ADDENDUM NUMBER 11

NOTIFICATION DATE:	SOLICITATION TITLE:	SOLICITATION NUMBER:	BID OPENING DATE & TIME:
05/17/2024	Naples Pier Reconstruction - ITB	24-011	5/30/2024 2:00PM

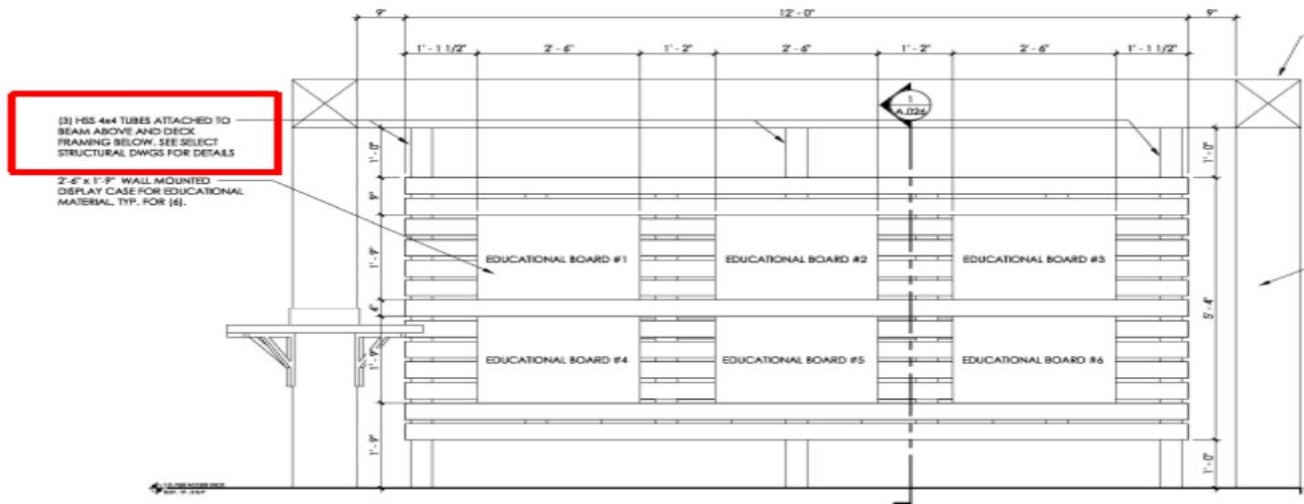
3. Can the City provide deeper soil borings as the soil borings provided do not go deep enough to make a determination on pile length for the temporary trestle . We would be guessing at this point....and our best guess is 130-200' pile in the water and 80-140' pile on the beach based on assuming a 25BPF soil beyond the boring.

Answer: No, we will not be able to provide deeper soil borings at this time. Deeper soil borings would require re-mobilizing a barge and drill rig and would take several weeks to complete. Design of the temporary trestle is the responsibility of the contractor.

1 EDUCATIONAL WALL DETAIL
SCALE: 3/4" = 1'-0"

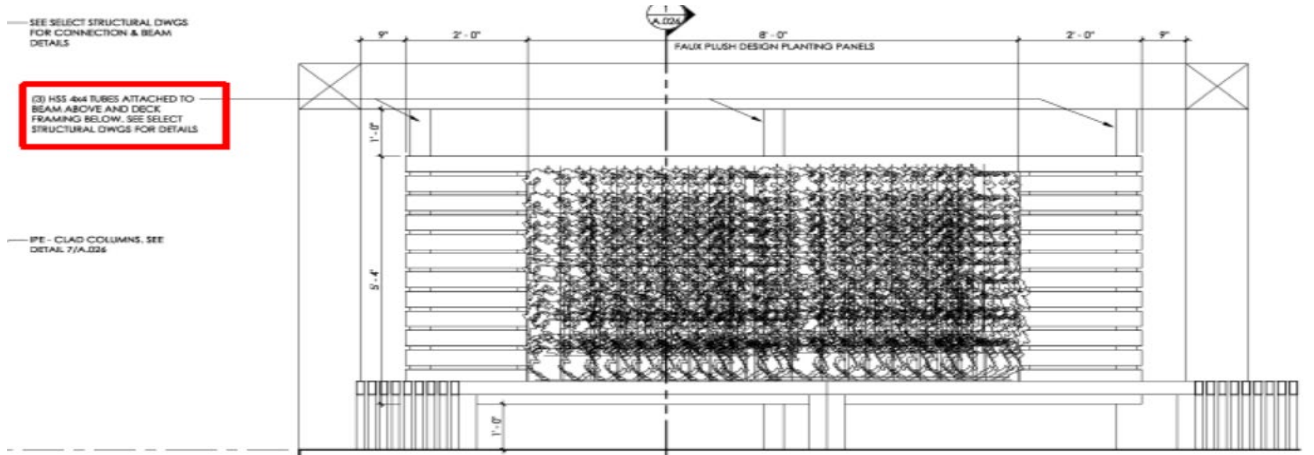
1. On sheet A.025, the details show exposed HSS tube steel at the Education Wall and IPE Wall. Is this steel to be field painted

5. On sheet A.025, the details show exposed HSS tube steel at the Education Wall and IPE Wall. Is this steel to be field painted?

Answer: They are to be left unpainted.

Answer: No, they are to be left unpainted as they are stainless steel.
